Not secure | forestsclearance.nic.in/viewreport.aspx?pid=FP/UK/ROAD/47739/2020

B-2.4 Component wise breakup

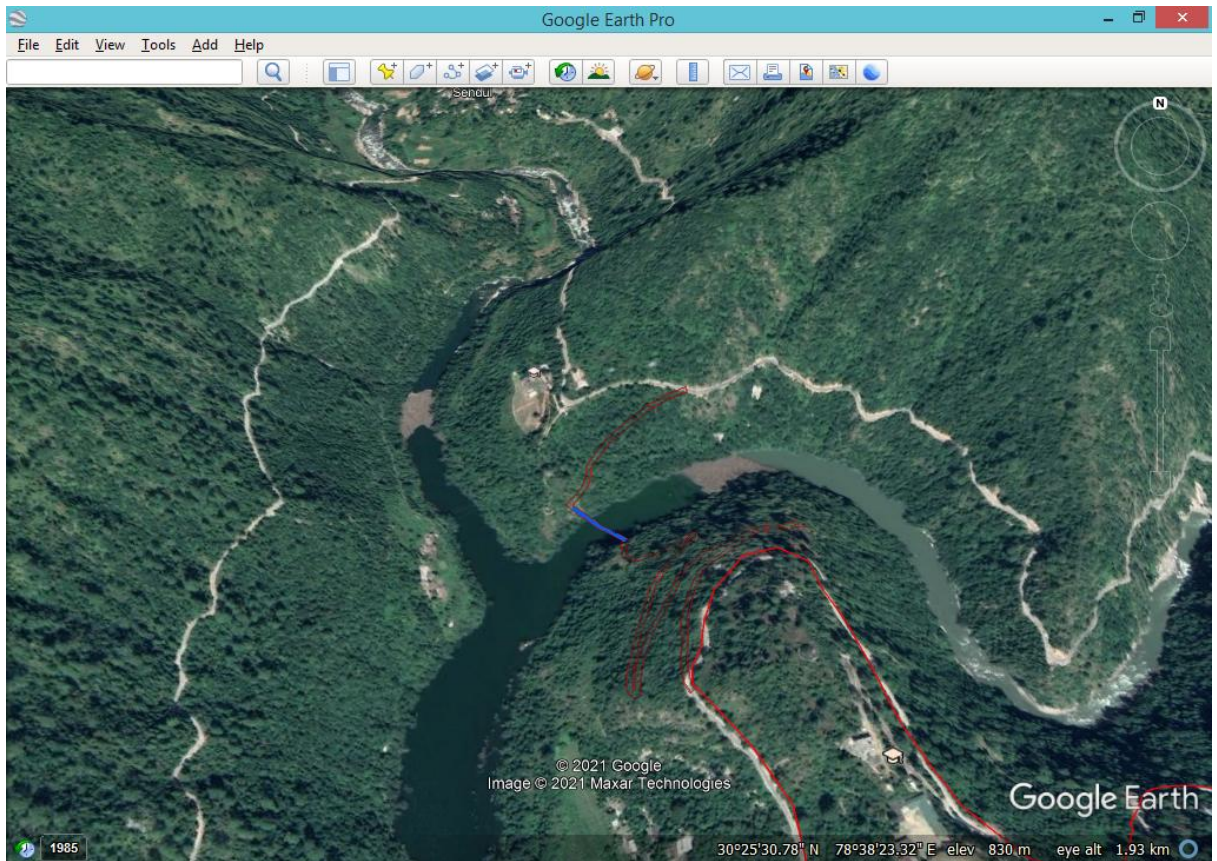
- 1- On observing the KML file the proposed alignment is passed through a river but no bridge component is shown in the component wise break up- Kindly clarify.
